MANDATORY SERVICE BULLETIN NO. MSB 40-023

DA 40 D

1.4 Subject

Modification of the fuel system.

Benennung: **Kraftstoffsystem installation**
Fuel System installation

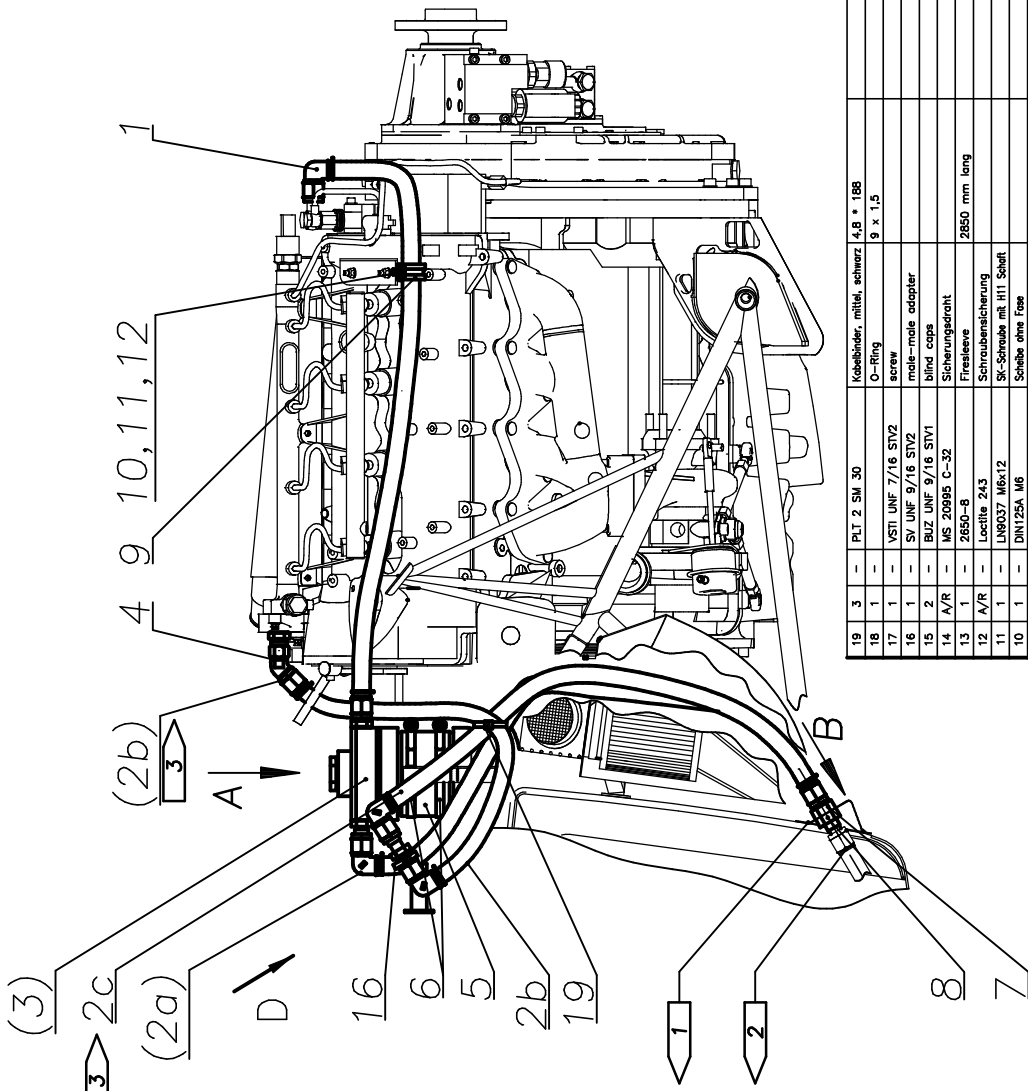
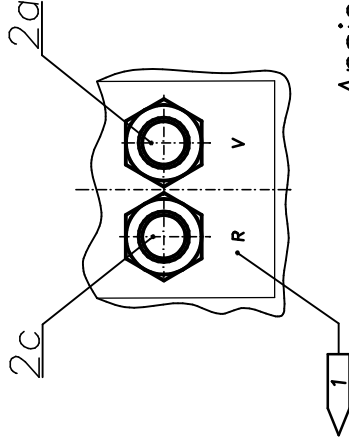
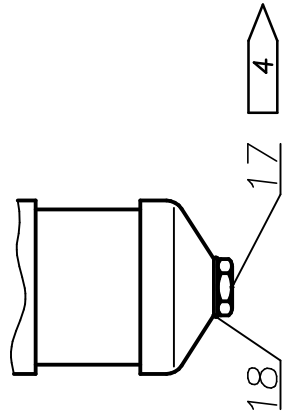
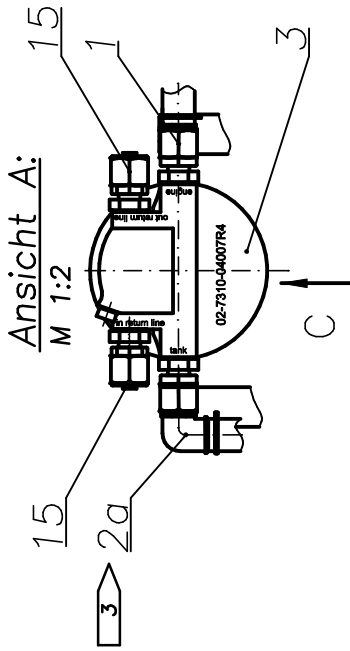
1	Remove upper and lower cowling in accordance with Airplane Maintenance Manual, Doc. No. 6.02.01.
2	Remove fuel hoses from the fuel filter housing.
3	Remove fuel filter housing by removing the clamps.
4	Install new fitting caps p/n 60.1610 (item 15 on dwg. no. D4D-7306-00-00"a") to the connections of the fuel return lines in the housing cap of the filter.
5	Remove the drain valve from the ground of the housing.
6	Install bolt and O-Ring p/n 60.1700 and 60.1705 (items 17 and 18 on dwg. no. D4D-7306-00-00"a") instead of the drain valve and glue with Loctite 243.
7	Install filter housing with clamps to the filter mount.
8	Connect the fuel suction lines to the fuel filter housing.
9	Connect the fuel return line from the engine and the fuel return line to the fuel tank with the Male Adapter p/n 60.1615 (item 16 on dwg. no. D4D-7306-00-00"a").
10	Tighten fuel lines at the fuel filter mount with ty-rap.

- 1 Fuel Flange Einbau gezeigt in D4D-7103-00-00.
- 2 Fuel flange installation shown in D4D-7103-00-00.
- 3 Kraftstoffleitungsinstallation gezeigt in D4D-2823-10-00.
- 4 Fuel hose installation shown in D4D-2823-10-00.
- Alle Kraftstoffleitungen mit Pos. 13, Firesleeve, überzogen. Pos 13 mit Pos. 14, Sicherungsdraht, an beiden Enden sichern.
- 1 Pull item 13, Firesleeve, over all fuel hoses. Secure item 13 with item 14, lock wire on both ends.
- Filter Drain Valve wird durch Position 17 ersetzt.
- 1 Filter drain valve has to be replaced by item 17.

12	Ventilate the fuel system in accordance with Airplane Maintenance Manual, Doc. No. 6.02.01, chpt. 28-21-00.
13	Ensure a tight fit of all parts.
14	Check for foreign objects.
15	Perform an engine run up until engine temperatures are in the green range. Then shut down engine.
16	Check engine for fuel leakage.
17	Install upper and lower cowlings in accordance with Airplane Maintenance Manual, Doc. No. 6.02.01.
